Re: Specific Development Plan
2801 Marshall Court

Re: Review of the proposed Planned Unit Development (PUD): Specific Development Plan (SDP)

This report reviews the Applicant's updated Specific Development Plan, dated July 30, 2018, with modifications responding to the GDP recommendation.

C-1.2

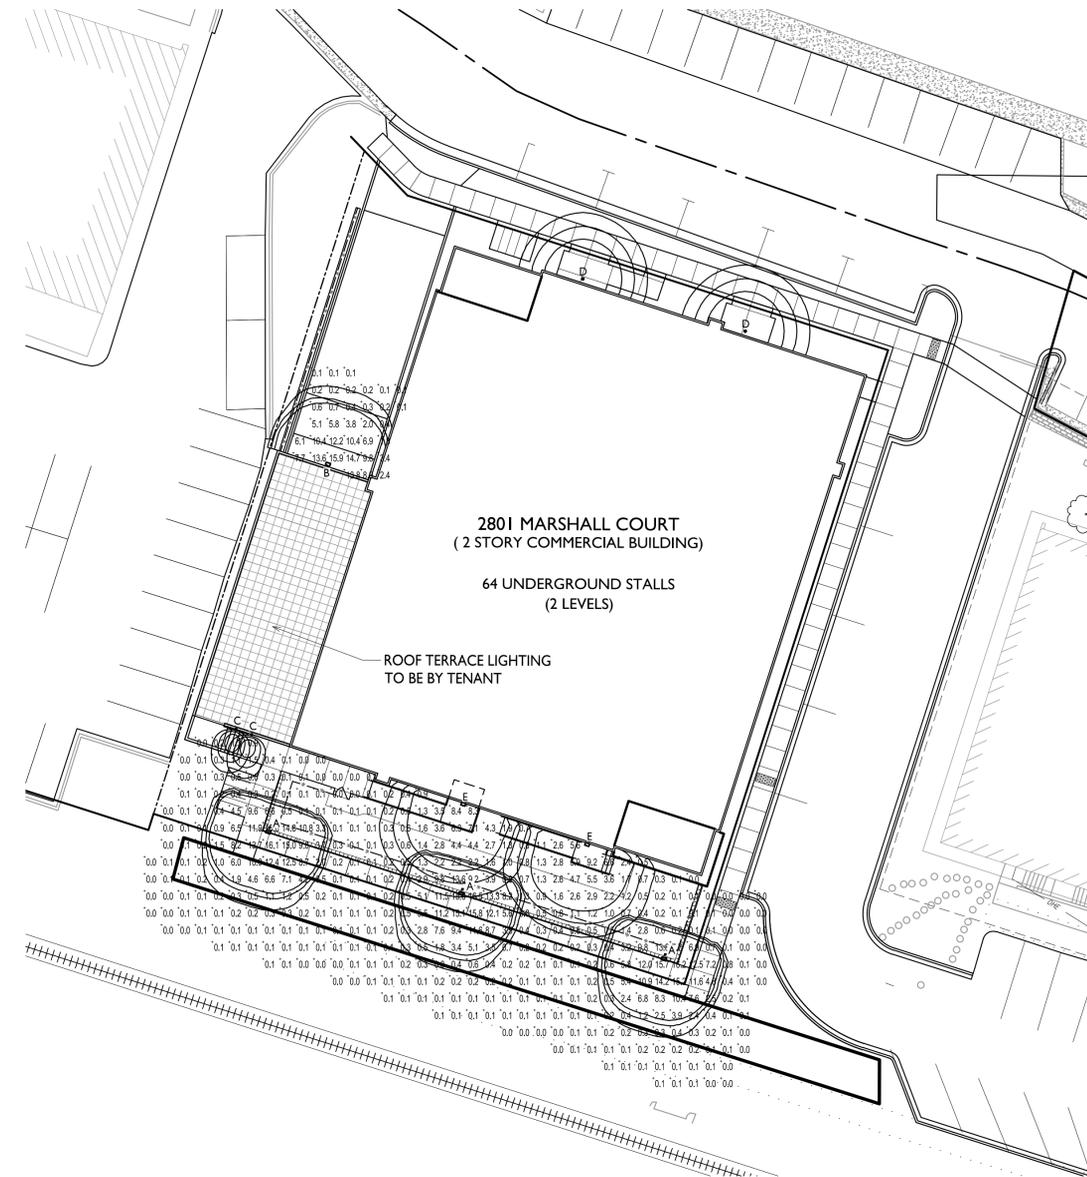
- Sheet C-1.2: The Site Lighting Plan was provided in the GDP submittal. It depicts the use of full cutoff fixtures with LED bulbs throughout the site. All wall-mounted fixtures, and pole-mounted fixtures used in the outdoor play area, are set at eight feet. The result of the full cutoff fixtures and low mounting height is to limit spillover lighting to less than 0.5 footcandles around the site. In most areas, the level is below 0.2 footcandles. These levels are within the acceptable range.

1. The Exterior Lighting Plan dated June 2, 2018 and included in the General Development Plan submittal, shall be considered as part of the SDP submittal.
2. The project shall not be served on a regular basis with deliveries or pick-ups by semi- tractor/trailer trucks.
3. Exterior Signage shall be subject to subsequent detailed submittals and Design Review by the Plan Commission.

C-1.3

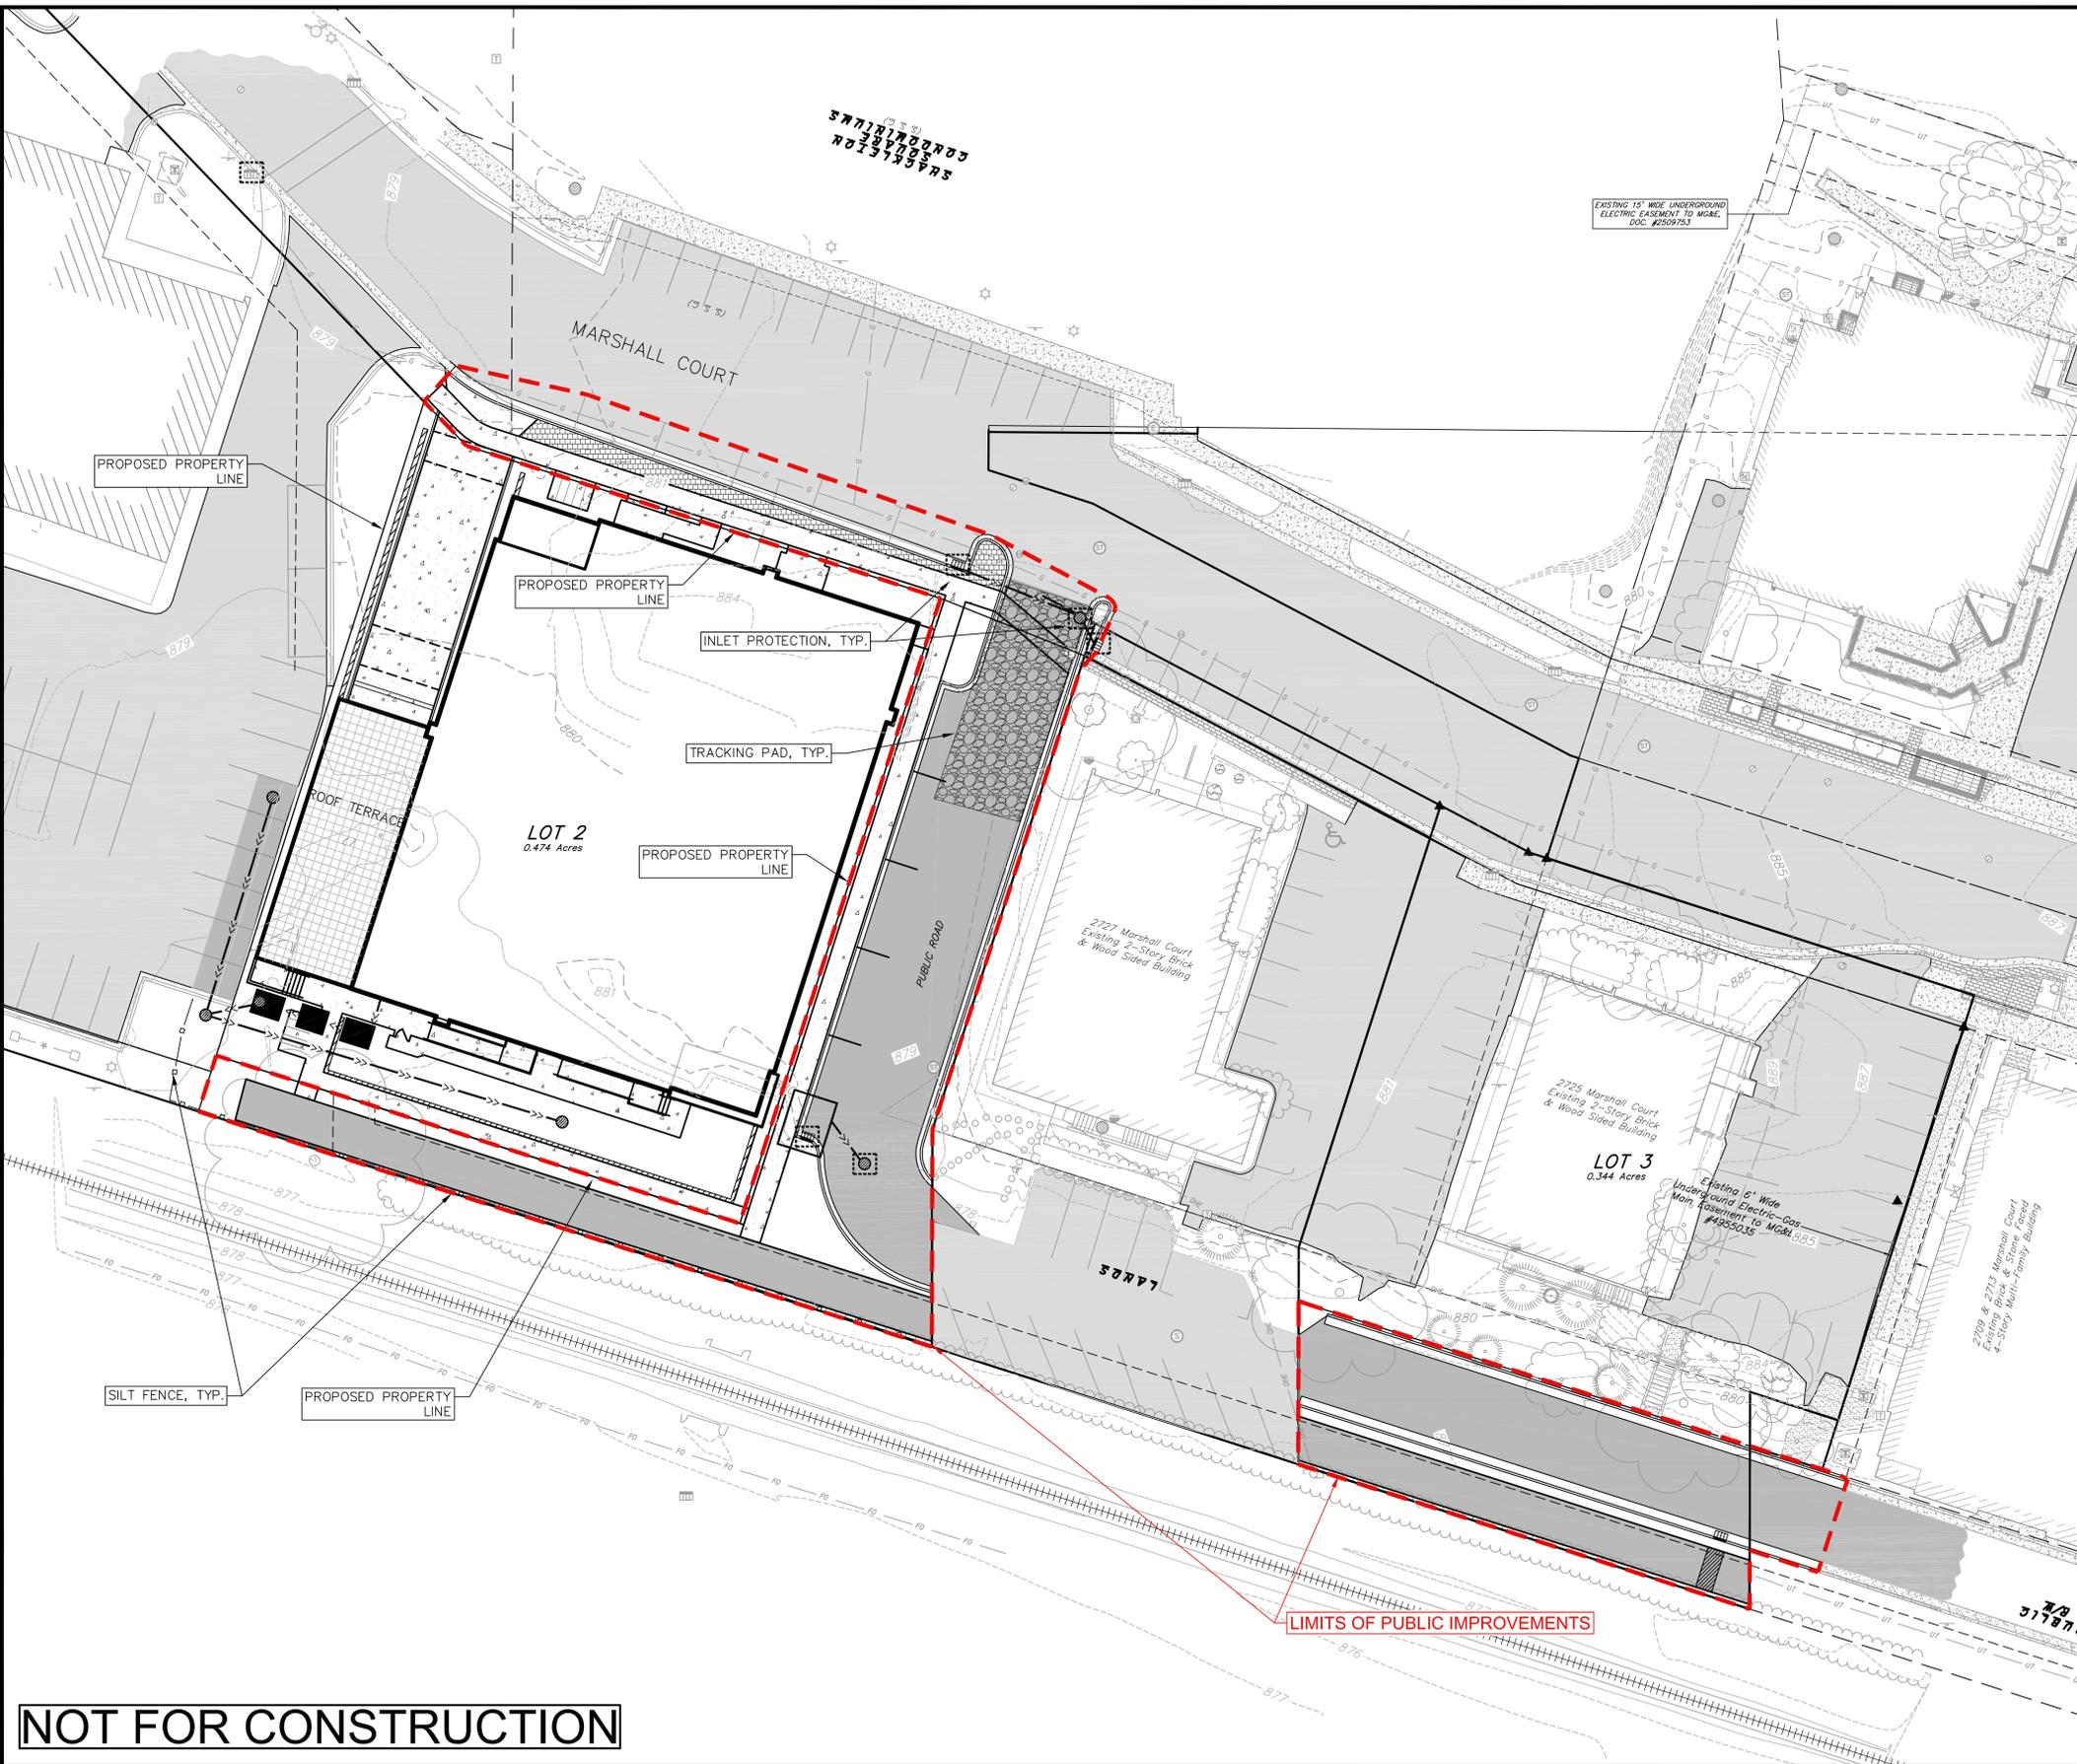
- Sheet C-1.3: An elaboration of the Site Plan depicting areas to be dedicated to the public. This sheet depicts the proposed land trade with the shopping center property to the west, that enables the continuation of the public bike trail; as well as the dedications for the rights-of-way for both Marshall Court, Catafalque Drive, and the public bike trail on the subject property, and in locations offsite on other property owned by the applicant to the east.

2 UNDERGROUND STORMWATER FACILITY
5.1 NOT TO SCALE

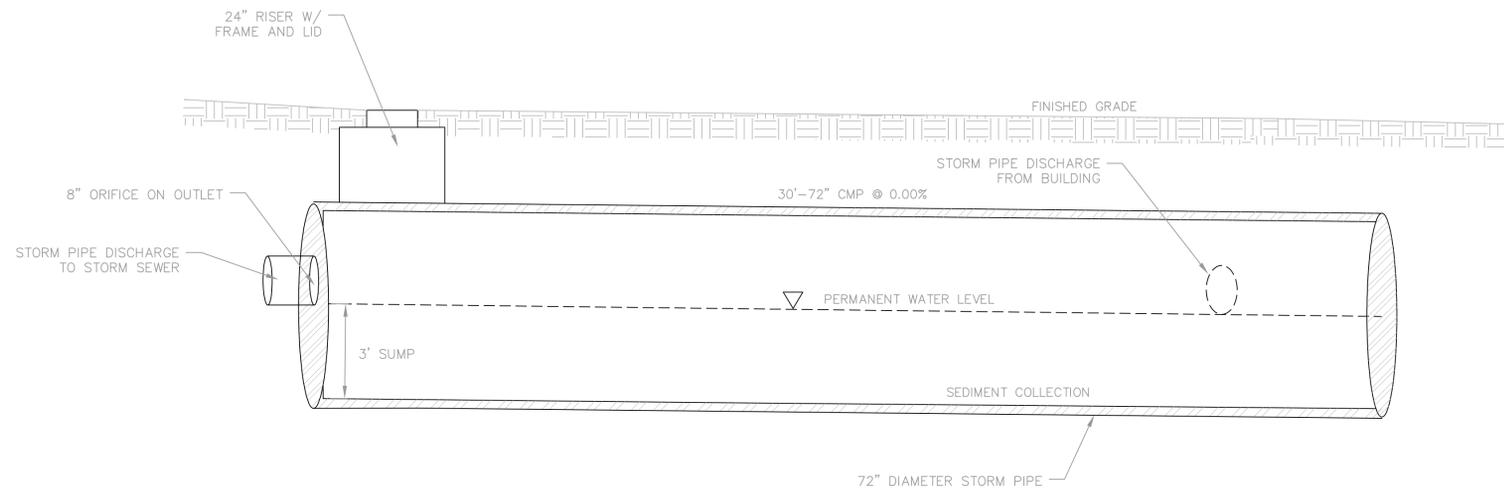
- Sheets C-5.0 and 5.1: Site Construction Details. Please note the design of the underground stormwater treatment facility on Sheet 5.1
- Sheet L-1.1: Landscaping Plan depicting the removal of all existing trees and shrubs on the subject property, and the preservation of the existing evergreen hedge just south of the site. The proposed landscaping provides building foundation shrubs around all four sides of the building – except along the west side of the site at the driveway to the underground parking area.

A-1.P1

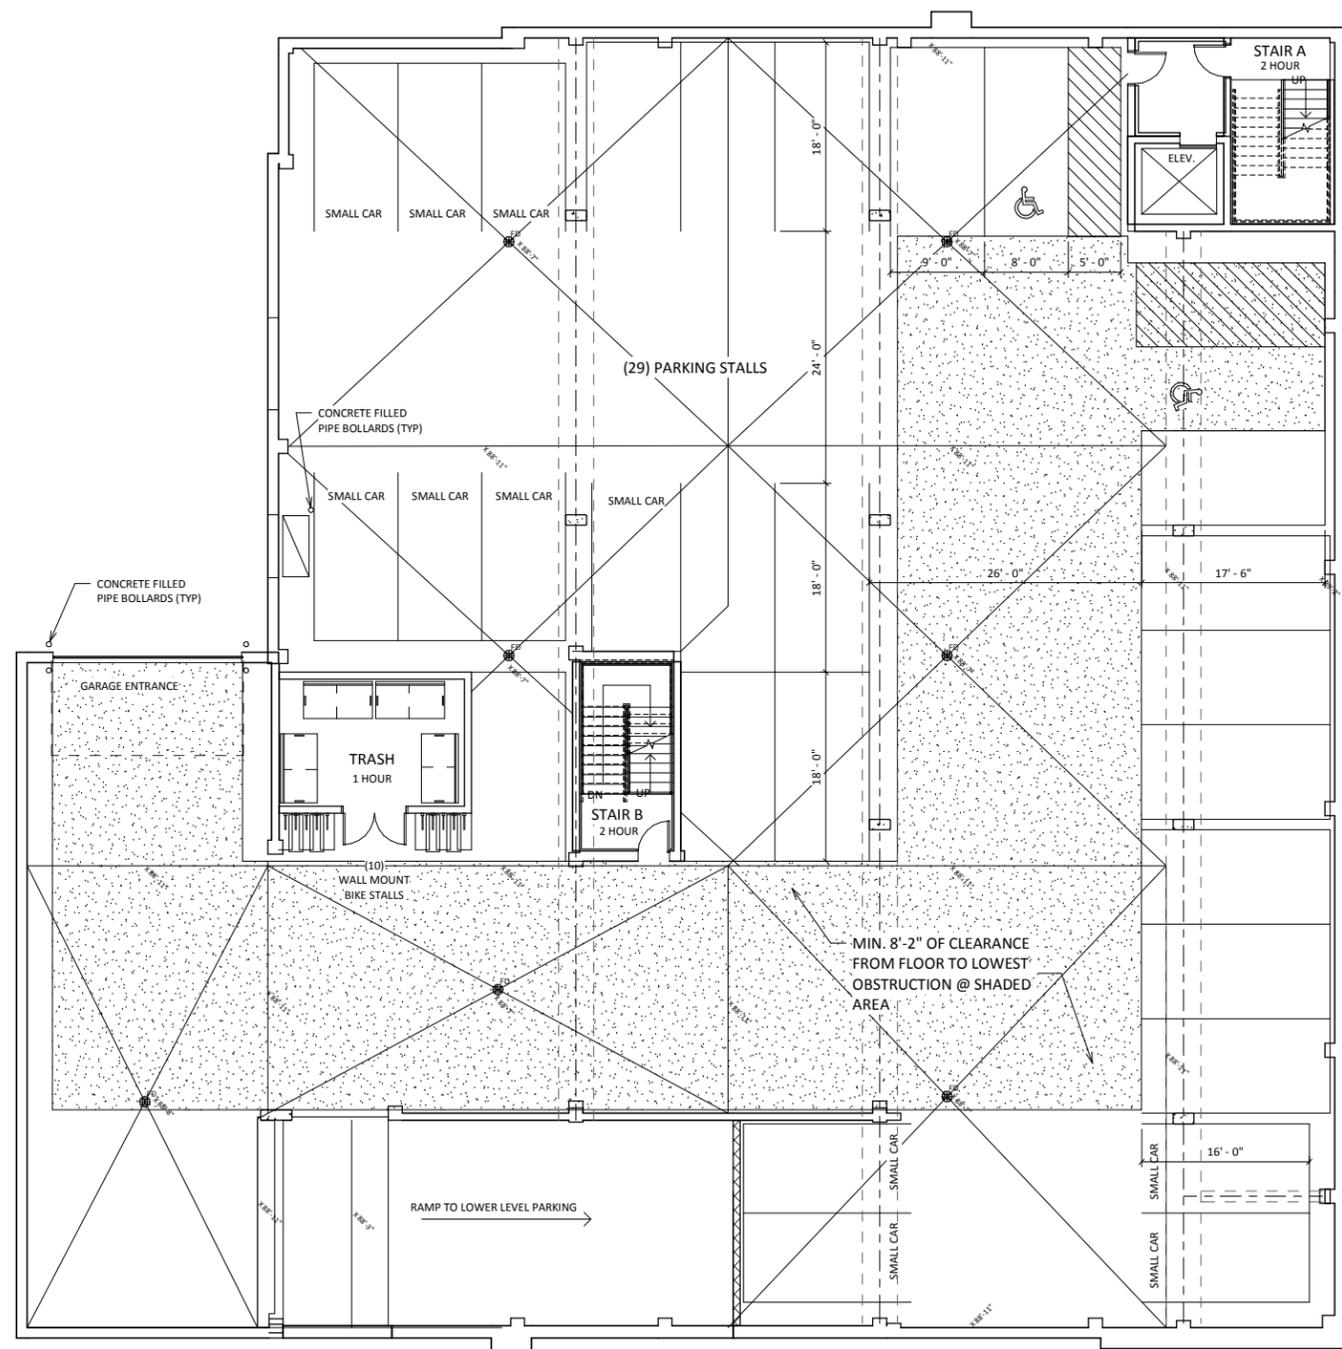
- Sheets A-1P1 and A-1P2: Architectural Floor Plans for the two levels of underground parking. Please note the interior room for trash containment on the upper level of parking, and on both levels the location of the elevator and stair core at the northeast corner of the building, under the main entry lobby.

A-1.3

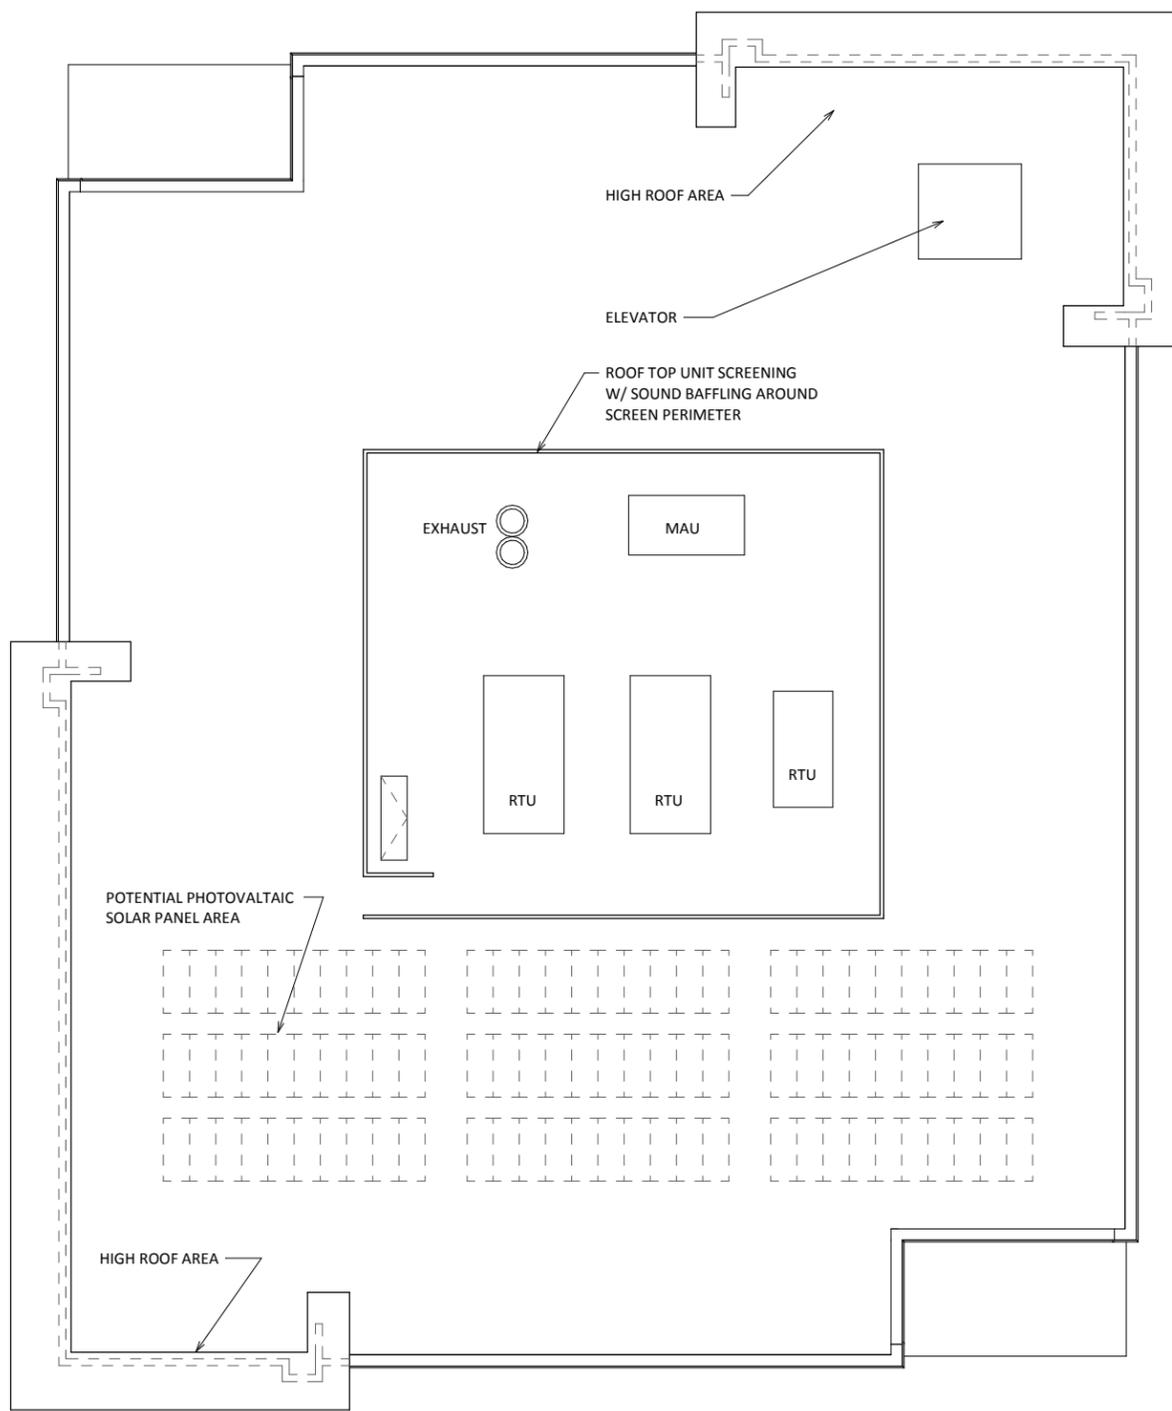
- Sheet A-1.3: Roof Plan depicting the location of rooftop mechanicals centered on the roof and surrounded by screening and sound baffles. A photovoltaic panel array is also proposed, centered on the south side of the roof where the screening panels will not create shade.
